[Docket No. 2000-SW-12-AD]

#### Airworthiness Directives; Eurocopter France Model AS350B, B1, B2, B3, BA, C, D, D1, and AS355E, F, F1, F2, and N Helicopters

**ACTION:** Notice of proposed rulemaking (NPRM).

Figure 1: Manual Inspection for play of the Tail Rotor Pitch Control Rod

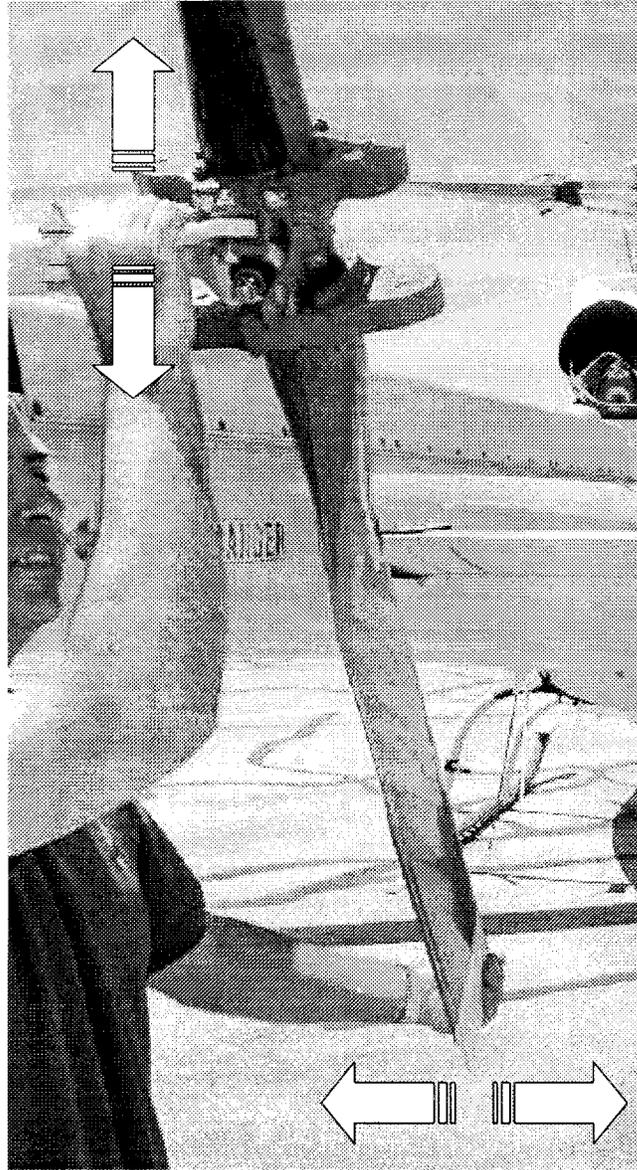
(a) Before the first flight of each day, configure the helicopter by ensuring the tail rotor pedals are in neutral position. If the helicopter is fitted with a tail rotor load compensator, discharge the accumulator as described in the flight manual. Inspect the bearing for play (Figure 1) on the helicopter, by observation and feel, by slightly moving the tail rotor blade in the flapping axis while monitoring the bearing for movement.

(1) If the Teflon cloth is found to be coming out of its normal position within the bearing, totally or partially, replace the control rod with an airworthy control rod before further flight.

Figure 2. Play Measurement on Tail Rotor Pitch Control Rod

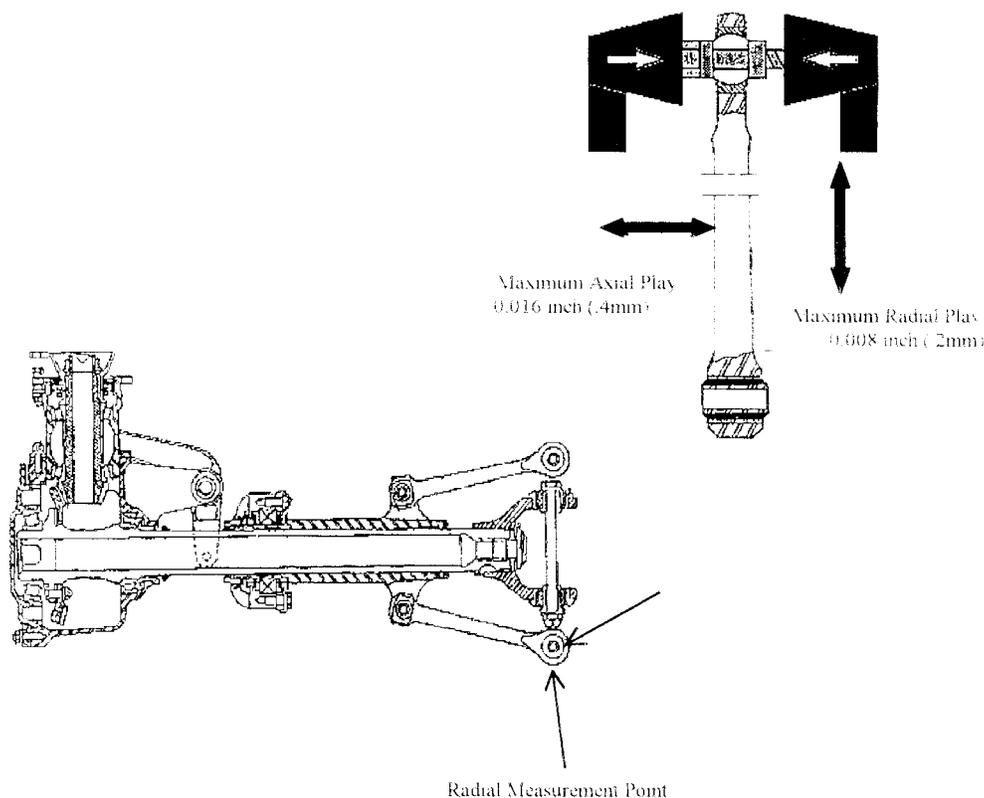
(2) If play is detected, measure the bearing wear using a dial indicator as shown in Figure 2. Perform the following steps (Figure 2) unless they were accomplished within the last 30 hours TIS.

(i) Remove the control rod.

(ii) Install a bolt, washers, and a nut to secure the bearing.

(iii) Mount the bearing in a vise as shown in Figure 2.

(iv) Using a dial indicator, take two radial measurements in the areas shown by the two arrows.

(v) Take axial measurements in the area shown by an arrow.

(vi) Record the hours of operation on each control rod.

(vii) If the radial play exceeds 0.008 inch or axial play exceeds 0.016 inch, replace the

control rod with an airworthy control rod before further flight.

(3) If the radial and axial play are within limits, reinstall the control rod.

(4) At intervals not to exceed 30 hours TIS, remove the control rod and measure the bearing wear with a dial indicator (Figure 2) using steps (a)(2)(i) through (a)(2)(vii).
